Access Compliance Report

Public Rights-of-Way

(Curb Ramps)

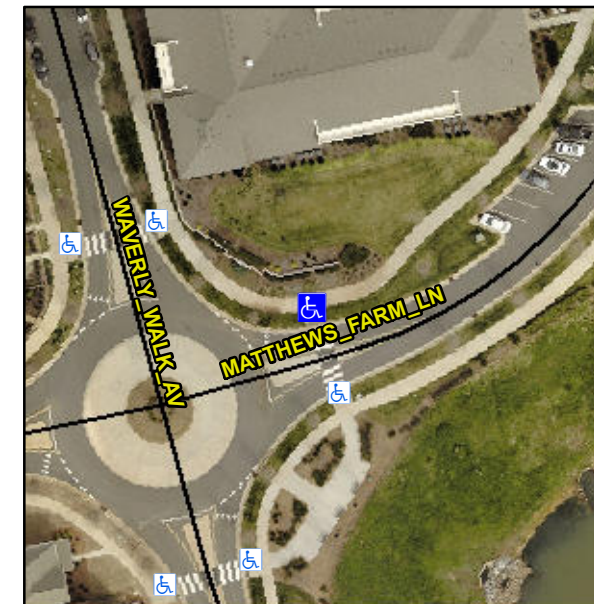
Intersection ID: 53488	Main Street: WAVERLY_WALK_AV	Cross Street: MATTHEWS_FARM_LN	Location: NE
ADA ID: 7651C00BD32C	Ramp Type: Perp	Initial Pass/Fail: Fail	Overall Compliance: No
Severity Score: 13.75			
Codes/Mitigation Info/Possible Solution		Field Measurements/Component Compliance

Not Found, R304.2.2, R304.5.3

Compliance	Description	Data	Compliance	Description	Data
N/A	Ramp Length (in)	95.0	No	Ramp Slope (%)	9.8
Yes	Ramp Width (in)	117.5	No	Ramp XSlope (%)	3.0
N/A	Flare Type LT	N/A	N/A	Flare Type RT	N/A
N/A	Flare Slope LT (%)	N/A	N/A	Flare Slope RT (%)	N/A
N/A	Flare Traversable LT?	N/A	N/A	Flare Traversable RT?	N/A
N/A	Landing Length (in)	N/A	N/A	DWS Provided?	N/A
N/A	Landing Width (in)	N/A	N/A	DWS Contrast?	N/A
N/A	Landing Slope (%)	N/A	N/A	DWS Length (in)	N/A
N/A	Landing X Slope (%)	N/A	N/A	DWS Full Width?	N/A
N/A	Landing Curb? (Y/N)	N/A	N/A	DWS Offset (in)	N/A
N/A	Shared Landing?	N/A			
N/A	Gutter Ponding?	N/A	N/A	Gutter Slope (%)	N/A
N/A	Gutter Lip Ht (in)	N/A	N/A	Gutter X Slope (%)	N/A
N/A	Painted X Walk1?	Yes	N/A	Painted X Walk2?	N/A
	X Walk 1 Direction	To S		X Walk 2 Direction	N/A
N/A	X Walk 1 Width (in)	121.0	N/A	X Walk 2 Width (in)	N/A
	X Walk 1 Slope (%)	0.9		X Walk 2 Slope (%)	N/A
	X Walk 1 X Slope (%)	1.5		X Walk 2 X Slope (%)	N/A

Remove & Replace Entire Ramp.
